STAFF RECOMMENDATION
1101 Petway Avenue
June 18, 2014

Application: New construction-infill
District: Eastwood Neighborhood Conservation Zoning Overlay
Council District: 06
Map and Parcel Number: 08301042200
Applicant: Randall Morgan
Project Lead: Paul Hoffman, paul.hoffman@nashville.gov

<p>Description of Project: This application is for construction of a two-family residence on a vacant lot.</p> <p>Recommendation Summary: Staff recommends disapproval of the proposed infill, finding that the project does not meet sections II.B.1. a for height, II.B.1.b for scale, II.B.1.c for rhythm of spacing, or II.B.1.f for orientation of the Eastwood Neighborhood Conservation Zoning Overlay Design Guidelines. Staff is not recommending approval with conditions, as the alterations necessary to meet the design guidelines will likely result in a redesign of the project.</p>	<p>Attachments A: Photographs B: Site Plan C: Elevations</p>
--	--

HISTORIC
 COMMISSION
 Site Plan

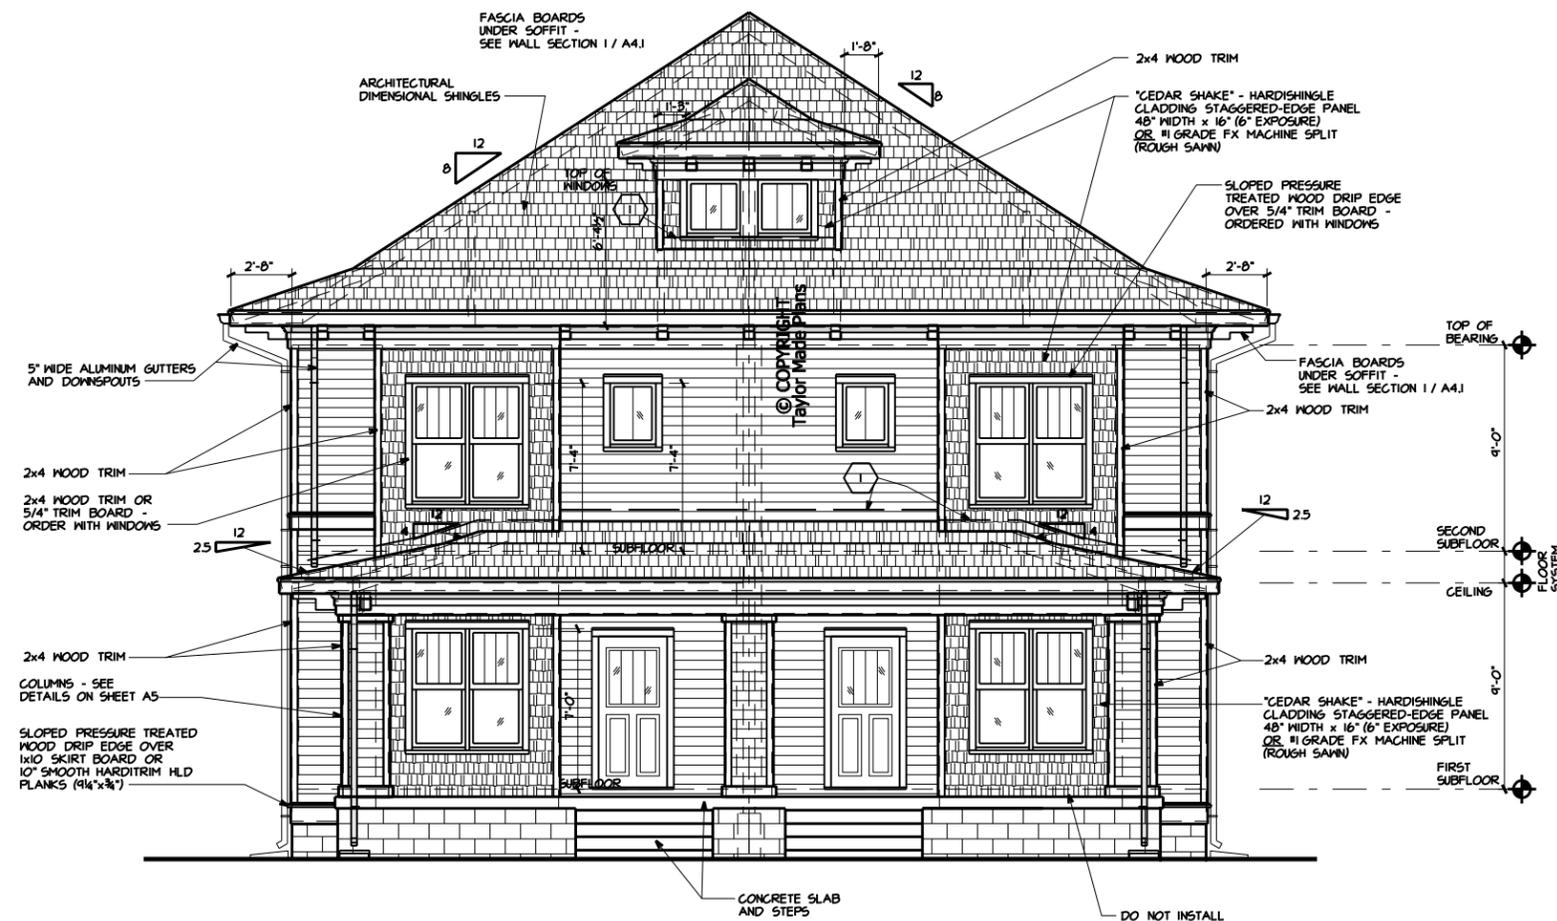
Setback & Rhythm of Spacing: The building is proposed to be centered on the lot, with setbacks of five feet (5') on the sides. The rear porch of the building would be approximately seventy feet (70') from the rear property line. The front setback is in line with the adjacent buildings.

The proposed width is several feet wider than contributing residences in the neighborhood which means that the building will not maintain the rhythm of spacing of the block. Therefore the proposal does not meet section II.B.1.c.

Orientation: The building will address Petway Avenue with the same orientation as historic homes. Each unit has a porch addressing the street. A new concrete walkway would connect each porch to the sidewalk. Vehicular access is at the rear of the lot. A parking pad for each unit is proposed, one off the side and the other from the rear alley.

FRONT ELEVATION

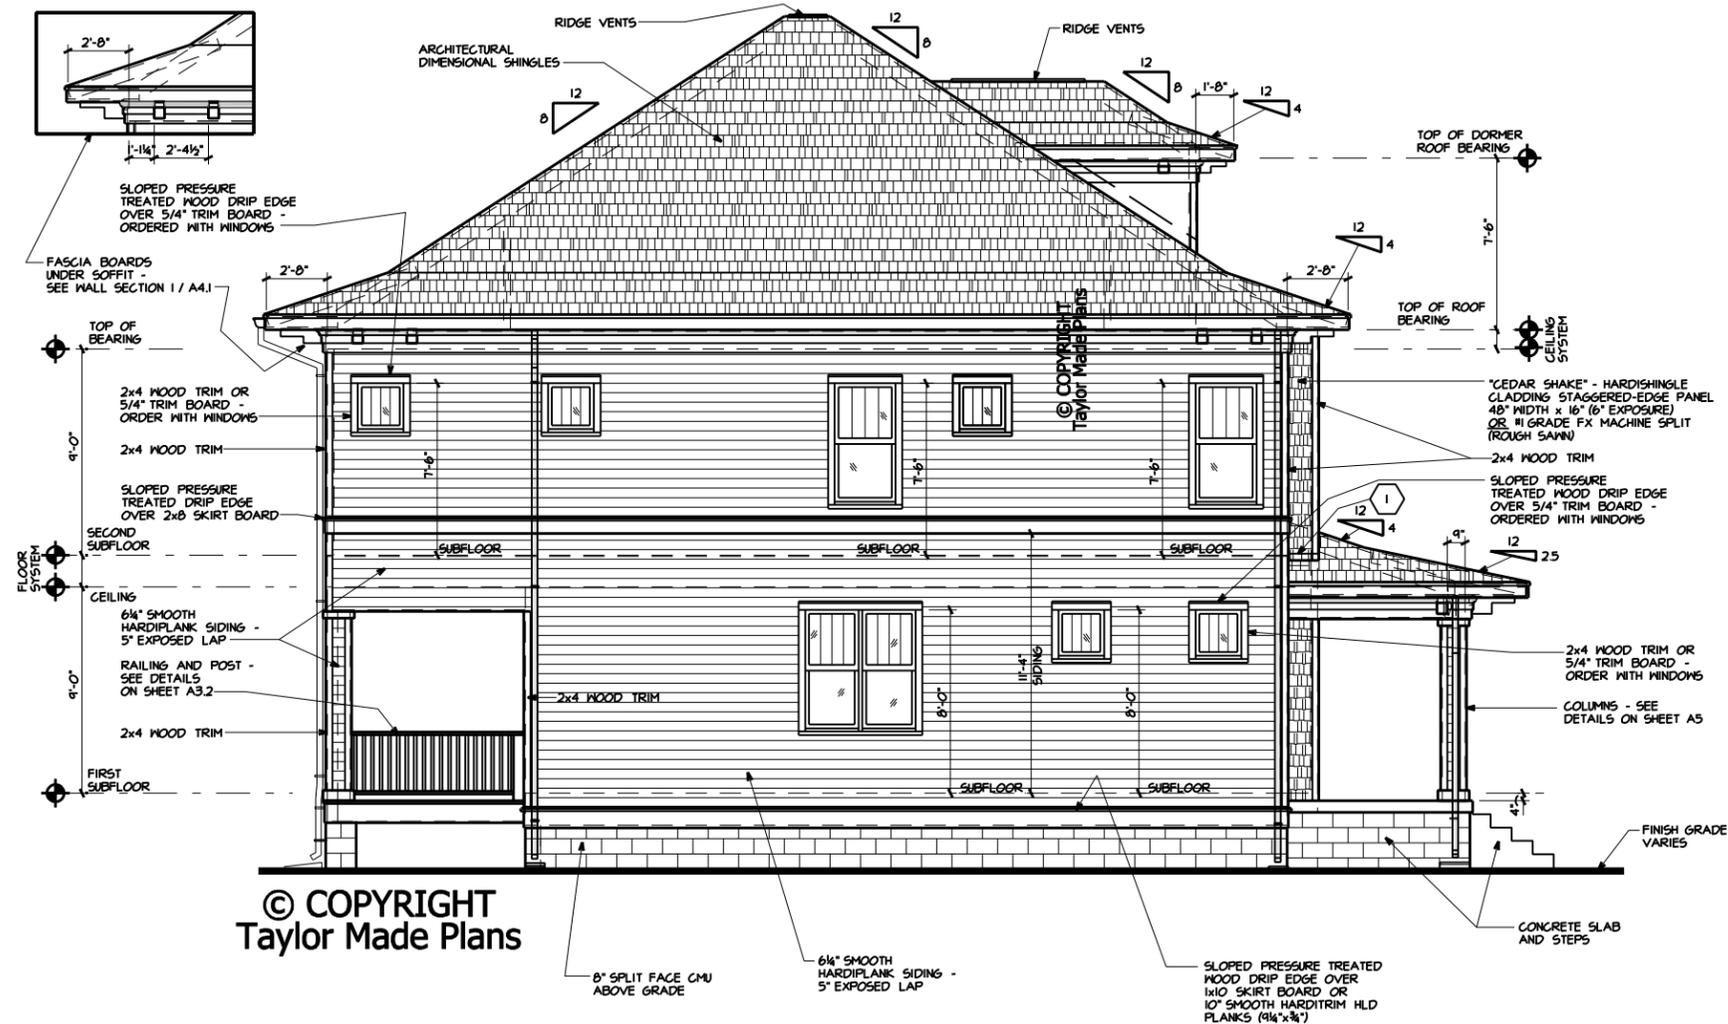
Height & Scale: The new building is proposed to be two stories and thirty-six feet (36') from grade. The contributing homes in the vicinity are one and one-half stories and range in height from fifteen feet to twenty-six feet (15'-26'). Foundation height is two feet (2'), eave height is twenty-three feet (23') from grade, and porch height is eleven feet (11'). Two-story homes also are not the norm for the context. The building is proposed to be forty feet (40') wide. The houses nearby range from twenty-eight feet (28') to thirty-six feet (36') wide. The proposed eight feet (8') of porch depth is compatible with historic porches.

Proportion and Rhythm of Openings: The windows on the front facades are generally twice as tall as they are wide, meeting the historic proportions of openings. The square windows in the dormer are common in that location. The small paired windows on the side elevations are appropriate as they mimic the small square windows that are often located aside a chimney on historic homes. The largest expanse of wall space without a window or door opening is approximately eleven feet (11').

FIRST FLOOR PLAN

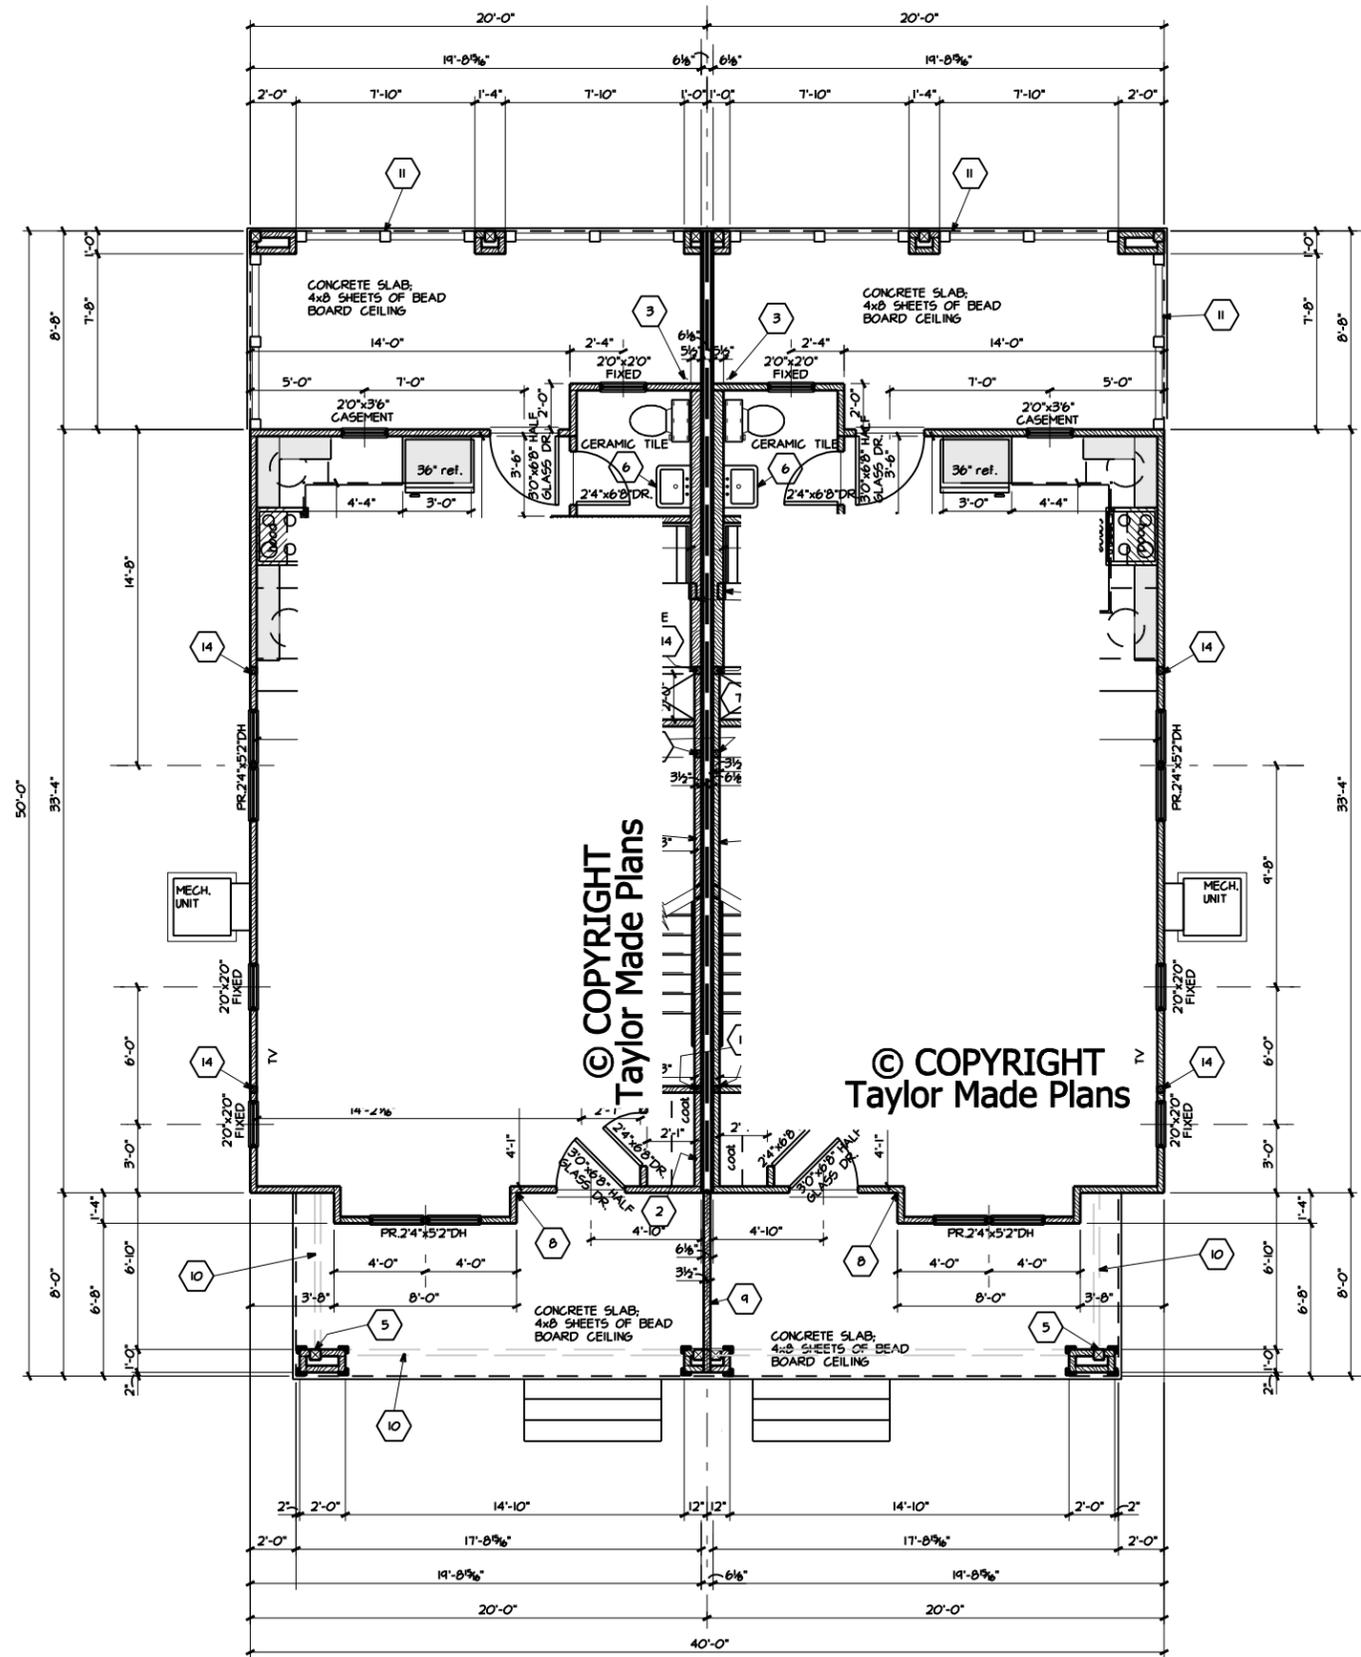
Although it isn't shown on the side elevations, the floor plan indicates a wall down the center of the porch, which staff recommends removing as it does not match the orientation of historic porches.
